July 2021 Draft for Public Review

A17.1-20XX/B44-XX, Safety Code for Elevators and Escalators
(Proposed Revisions of ASME A17.1-2019/CSA B44-19)

Record 08-1345

**Fig. I-13 Ceiling or Soffit Guard
 High Deck Escalators
 (6.1.3.3.11)**

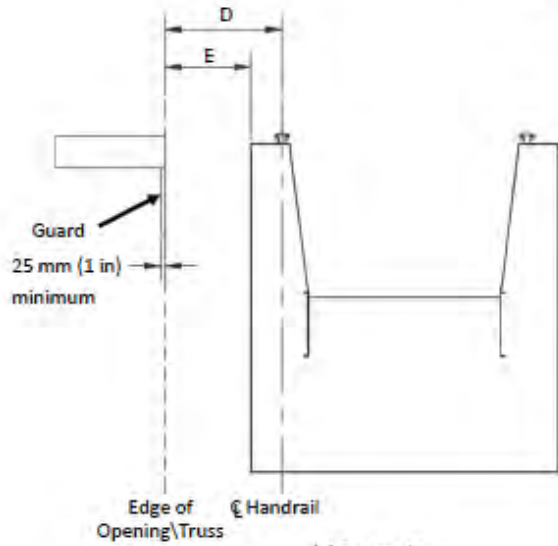
- Guard required when centerline of handrail is less than 600 mm (24 in) [Distance D] from edge of opening or adjacent escalator truss

- OR -

When edge of outer decking is less than 300 mm (12 in) [Distance E] from edge of opening or adjacent escalator truss

- The vertical edge of the guard shall be a minimum of 350 mm (14 in.) in length.
- The escalator side of the vertical face of the guard shall be flush with the face of the wellway or adjacent truss cladding.
- The exposed edge of the guard shall present a minimum width of 25 mm (1 in.) and a minimum radius of 12 mm (0.5 in.).
- Guards are permitted to be of glass or plastic, provided they meet the requirements of 6.1.3.3.3.

Rationale: To add clarifying diagrams for escalator ceiling intersection guards.

**Fig. I-14 Ceiling or Soffit Guard
 Low Deck Escalators
 (6.1.3.3.11)**

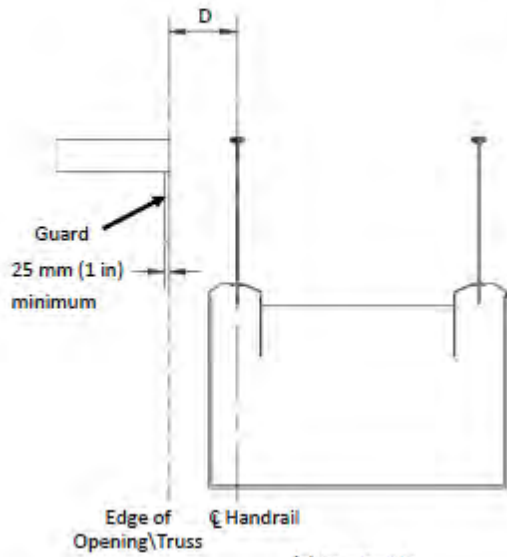
- Guard required when centerline of handrail is less than 350 mm (14 in) [Distance D] from edge of opening or adjacent escalator truss
- The vertical edge of the guard shall be a minimum of 350 mm (14 in.) in length.
- The escalator side of the vertical face of the guard shall be flush with the face of the wellway or adjacent truss cladding.
- The exposed edge of the guard shall present a minimum width of 25 mm (1 in.) and a minimum radius of 12 mm (0.5 in.).
- Guards are permitted to be of glass or plastic, provided they meet the requirements of 6.1.3.3.3.
